PROCLAMATION CALLING A SPECIAL MEETING OF THE BERKELEY CITY COUNCIL

Thursday, July 23, 2020

3 PROPOSED NORTH ELEVATION

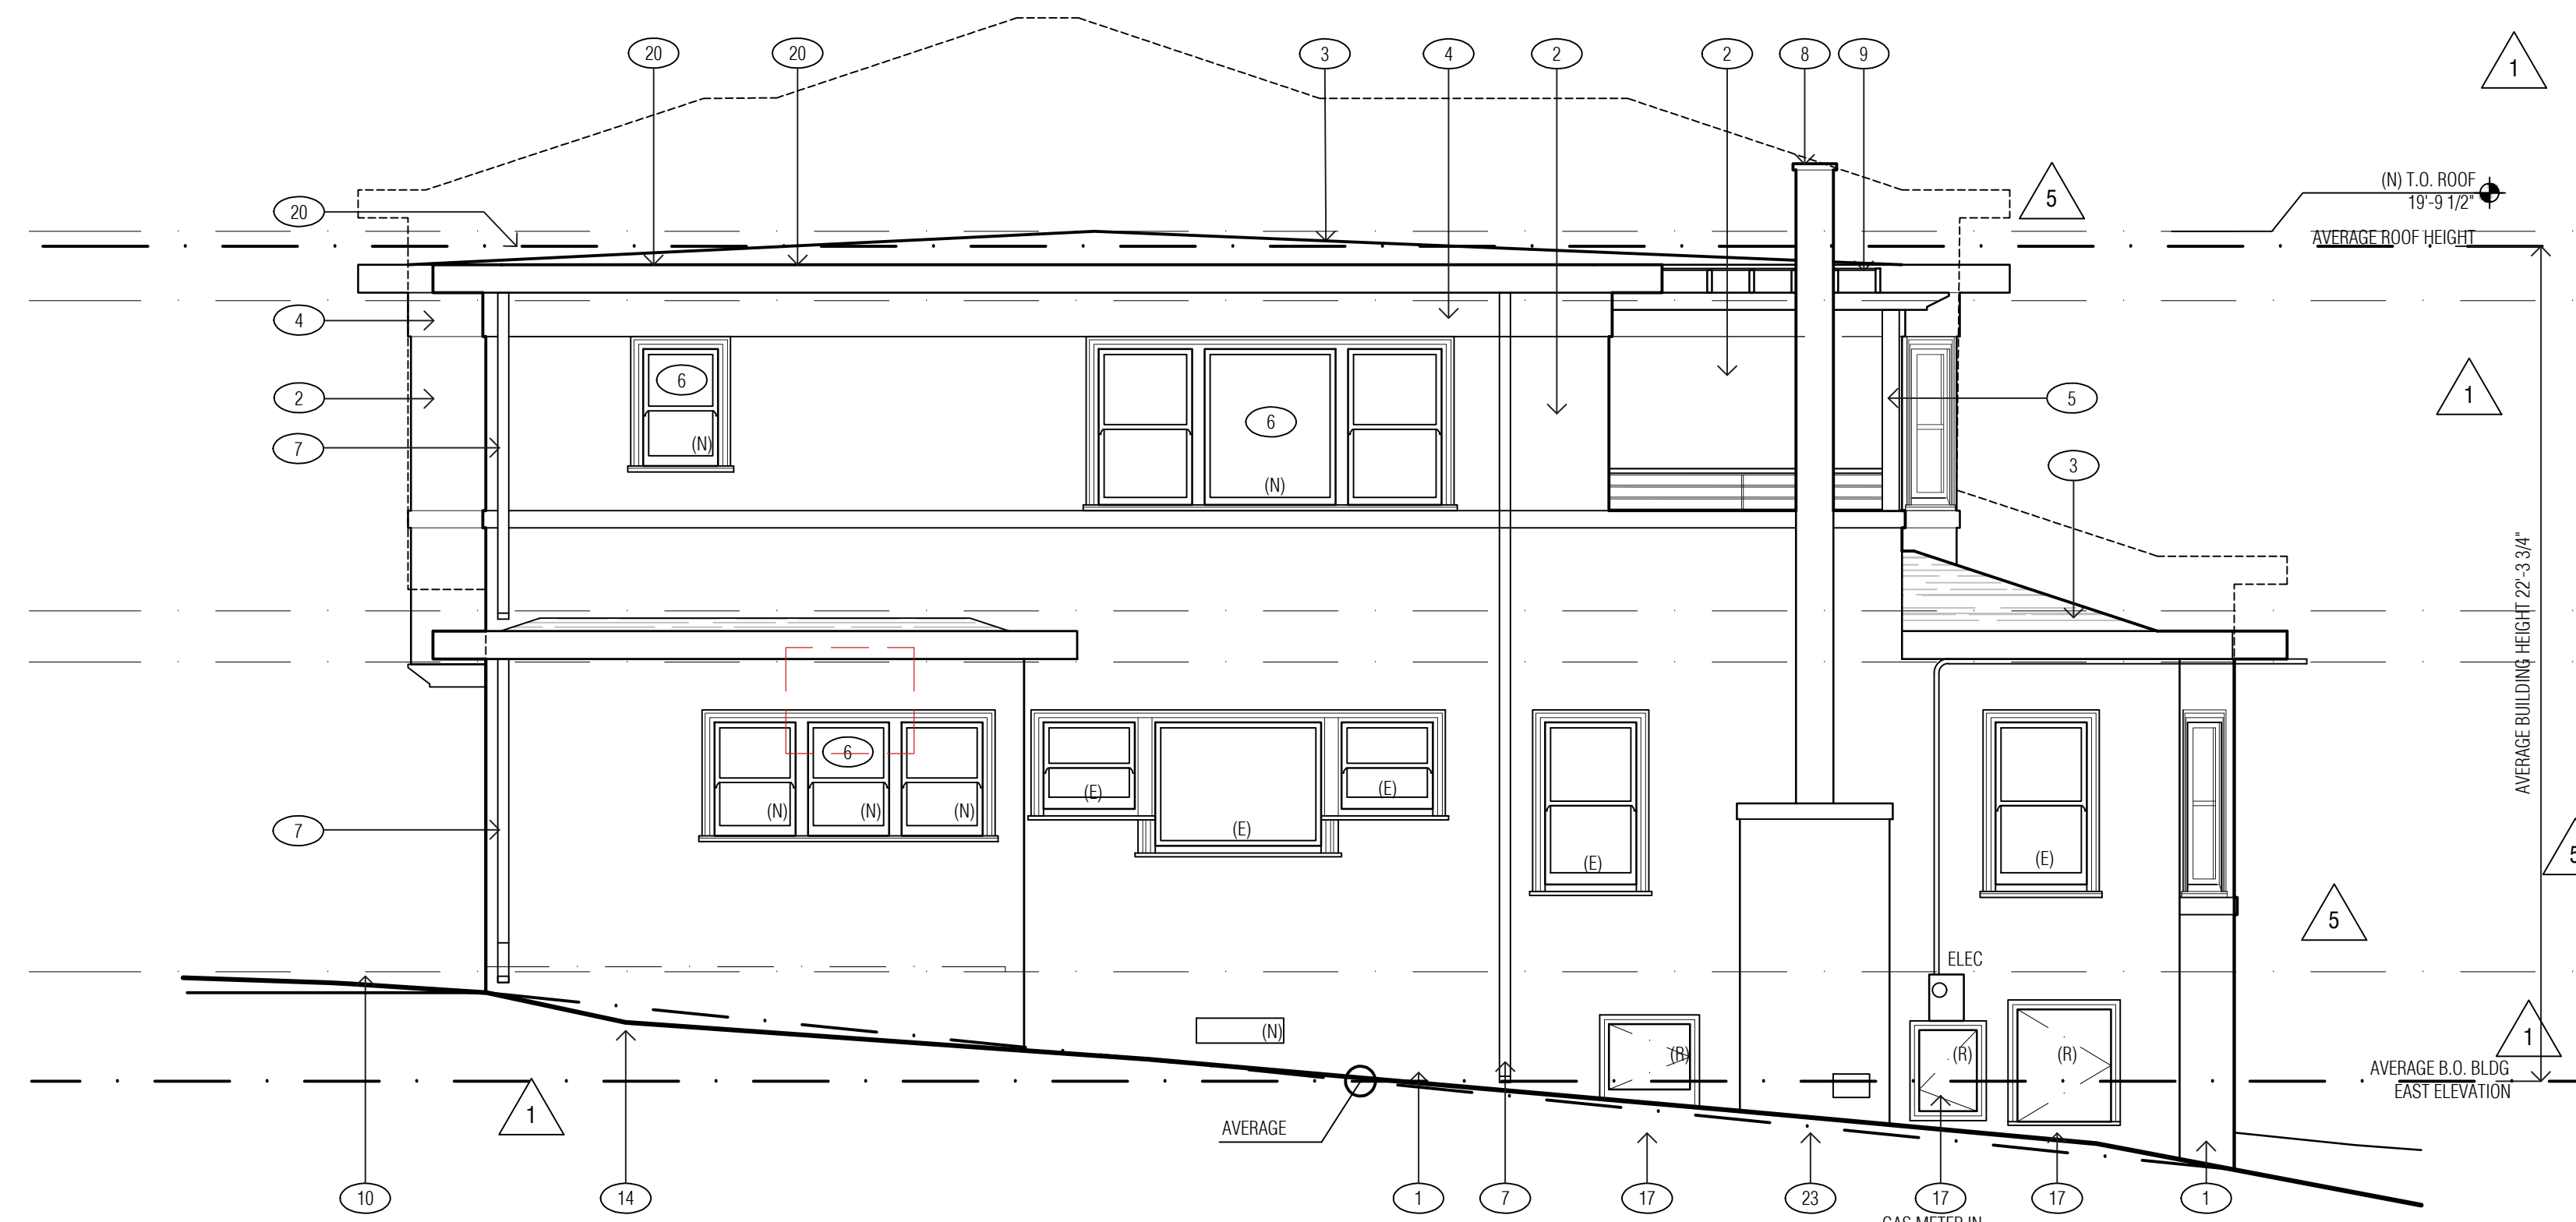
Response 2: The applicant revised the project at the direction of staff to lower the building height, by redesigning from a pitched roof design to an essentially flat roof and lowering the ceiling height of the second floor in such a way that the average height of the roof was reduced from 27 feet 1 ¼ inches to 23 feet 7 ½ inches (as shown in the south elevation on sheet A3.1 of the plans received June 10, 2020, Attachment 5).

On drawing A3.1 Eisenmann Architecture's current design shows the top of roof height at the east elevation to be 19'-9.5" from the average bottom of building. At the south elevation, that same dimension is 19'-6.75".
